SUNDRY NOTICES AND REPORTS ON WELLS

UTE MIN TRIBAL J # 2

XTO Energy Inc., proposes to P&A this well per the attached procedure.

Conditions of Approval - Notice of Intent to Abandon:

P&A'D WBD

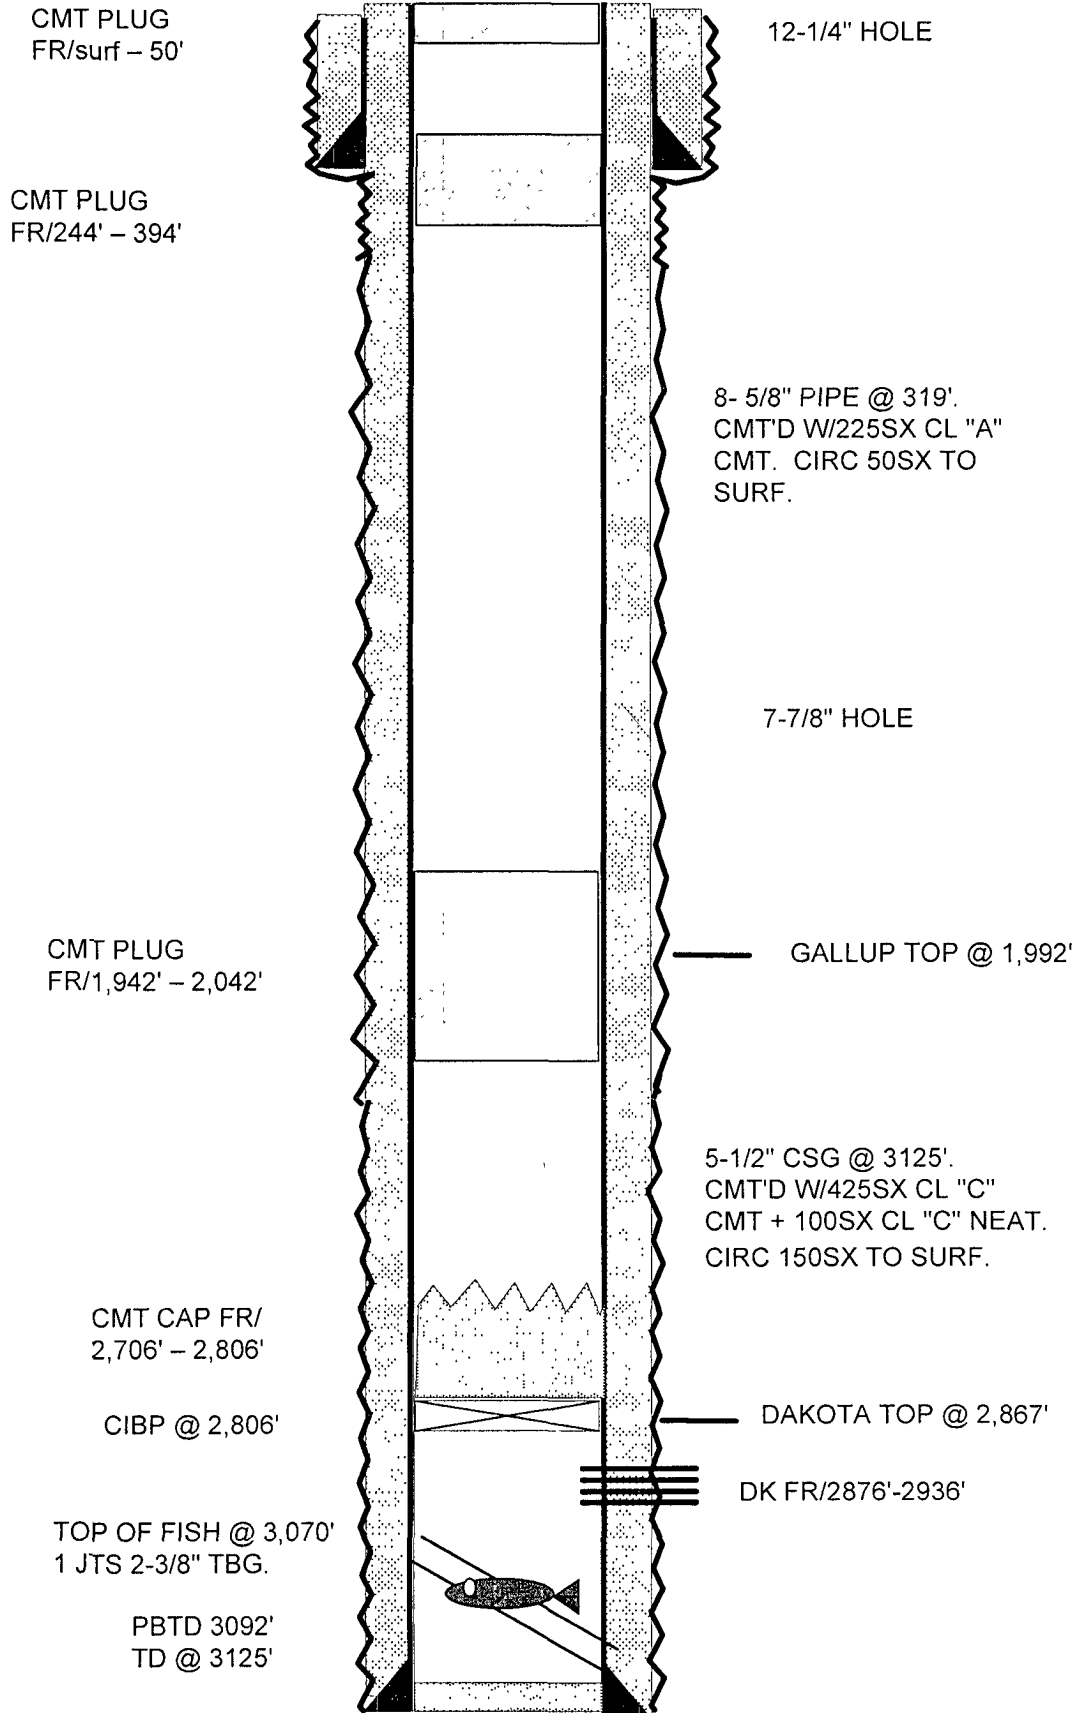
- 6a. Cement plugs placed inside casing shall have sufficient volume to fill a minimum of 100 ft. of the casing or annular void(s) between casings, plus 10% excess volume per 1000 ft. of depth.**

- 6b. Surface plugs must be a minimum of 50 ft. within casing and annular voids.**
 - 6c. Cement plugs placed to fill an open hole shall have sufficient volume to fill a minimum of 100 ft. of open hole, plus 10% excess volume per 1000 ft. of depth.**

- 6d. An additional 100 ft. cement plug must be placed midway between the Gallup and surface casing plugs.**
 - 6e. Tag the Gallup plug.**
7. The well must be filled with a wellbore mud sufficient to stabilize the wellbore. In the absence of any formation pressure data provided by the operator, this mud will have a minimum weight of **9 ppg**. The mud must be left between all plugs.
